re: Township of Muskoka Lakes - Fire Station 6 - Interior Renovations
 - Addendum One

ADDENDUM NUMBER ONE
TOWNSHIP OF MUSKOKA LAKES FIRE STATION NO. 6
DECEMBER 10, 2021

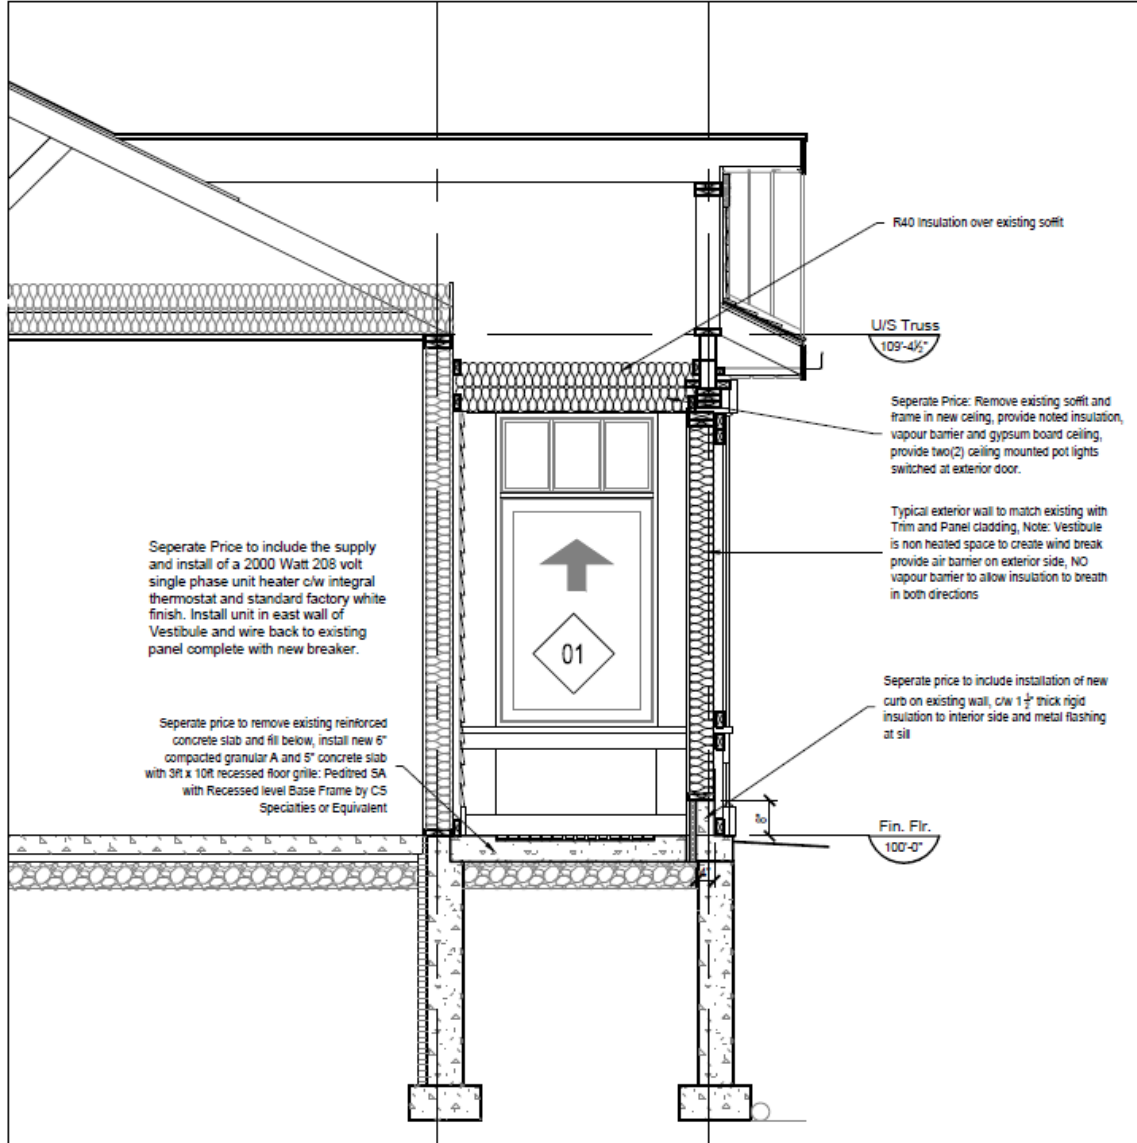
- .1 The Contractor to provide a Separate Price to remove the existing reinforced suspended concrete slab at the entrance vestibule location. Temporarily support existing structure. Install new curb, slab, floor grille, barriers and insulation as per sketch below. Include addition of electric heater and power supply:
